YAKUTAT AIRPORT RUNWAY & TAXIWAY LIGHTING IMPROVEMENTS

A.I.P. NO. 3-02-0327-13-99
PROJECT NO. 67522

"AS-BUILTS"

CONTROL SCHEMATIC – LIGHTING CONTROLS

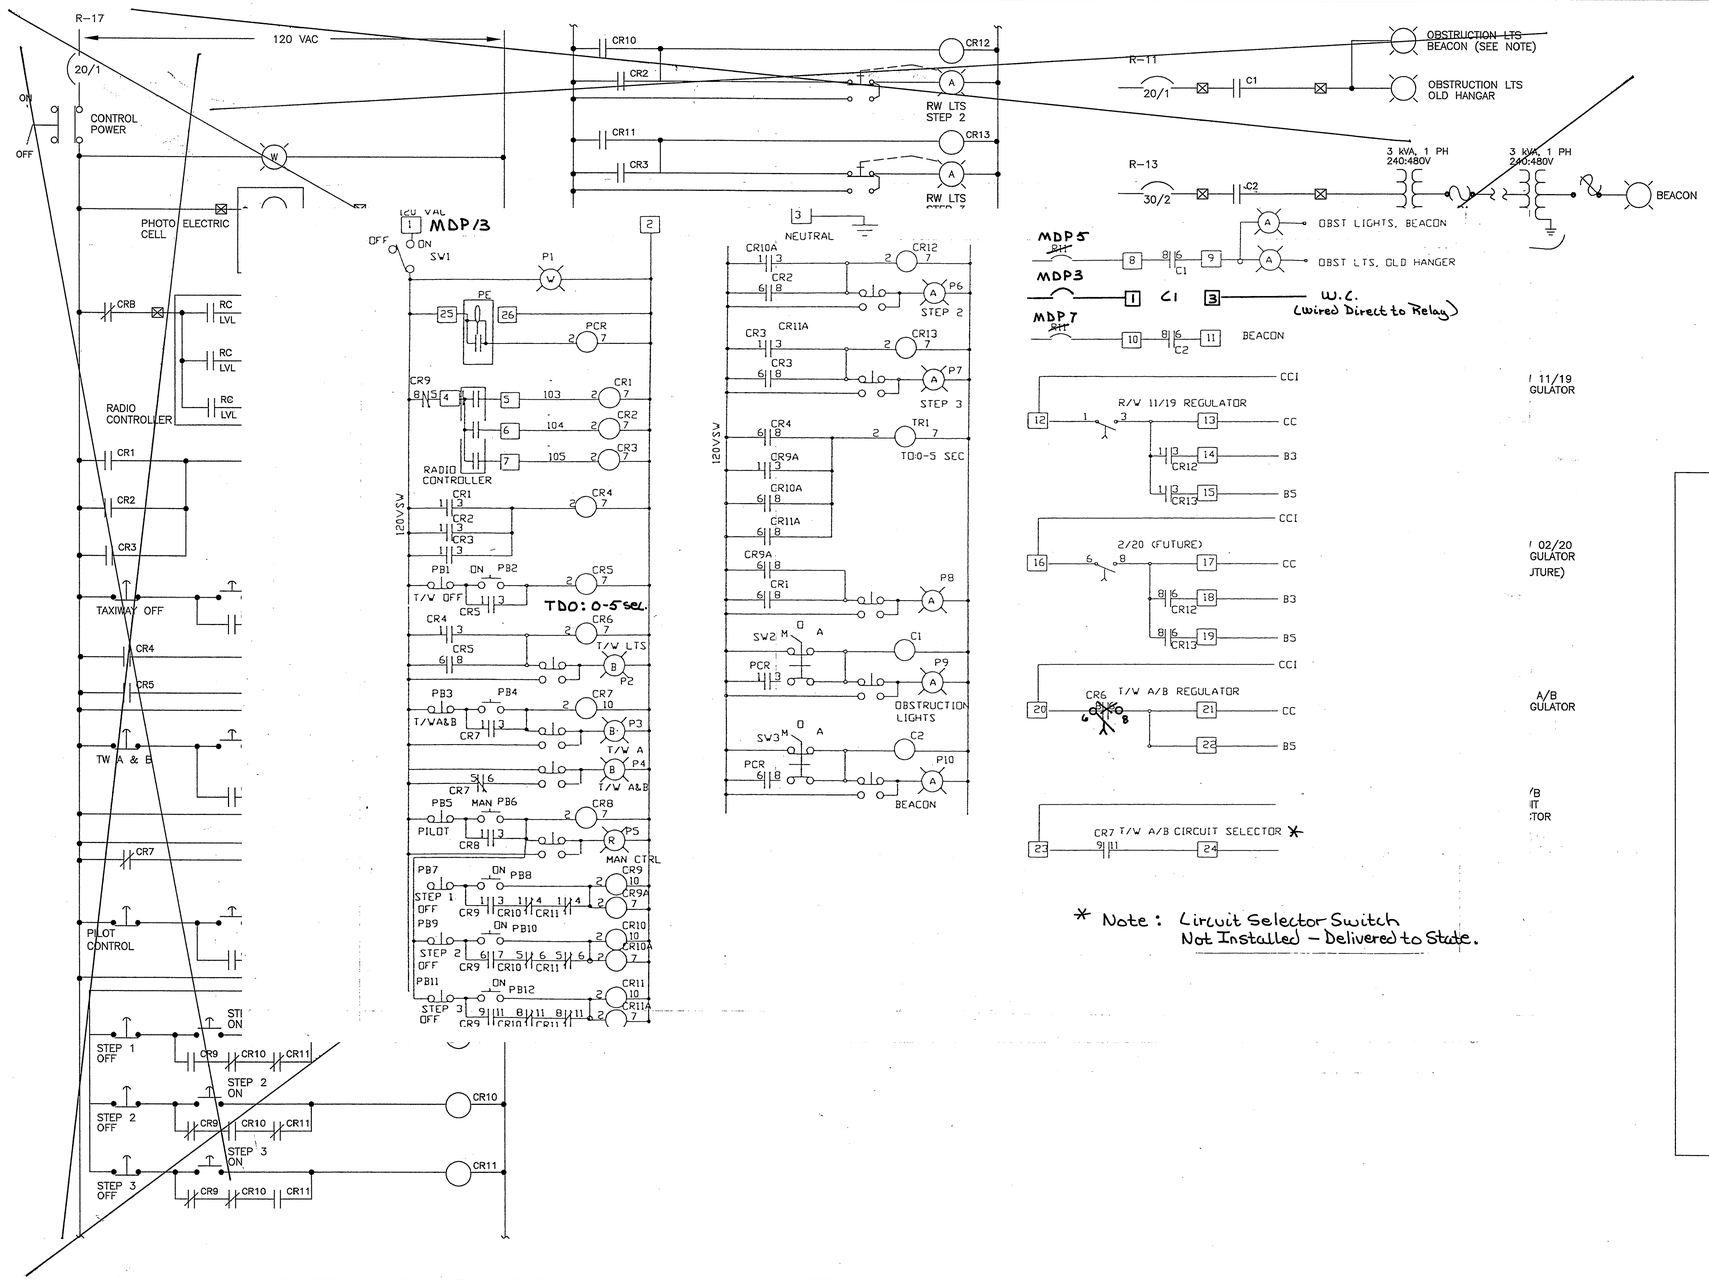
* Note: Circuit Selector Switch Not Installed – Delivered to State.

PANEL LAYOUT

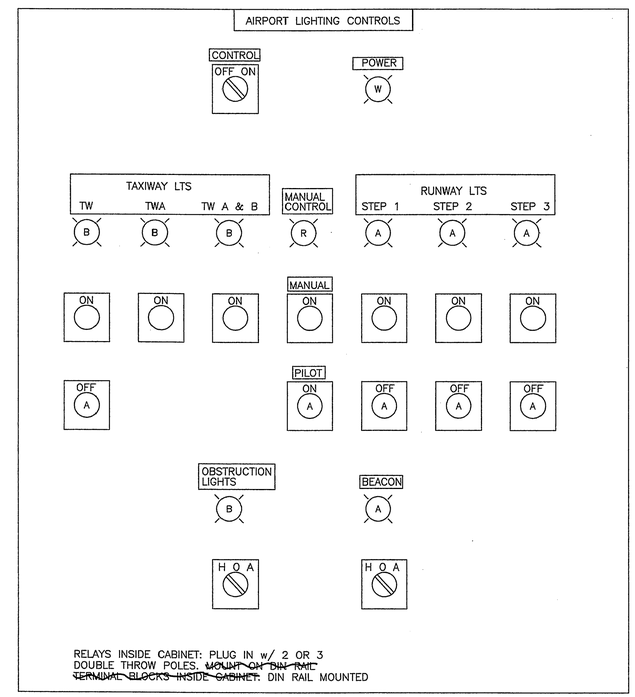
RELAYS INSIDE CABINET: PLUG IN w/ 2 OR 3 DOUBLE THROW POLES. ~~MOUNT ON DIN RAIL TERMINAL BLOCKS INSIDE CABINET.~~ DIN RAIL MOUNTED
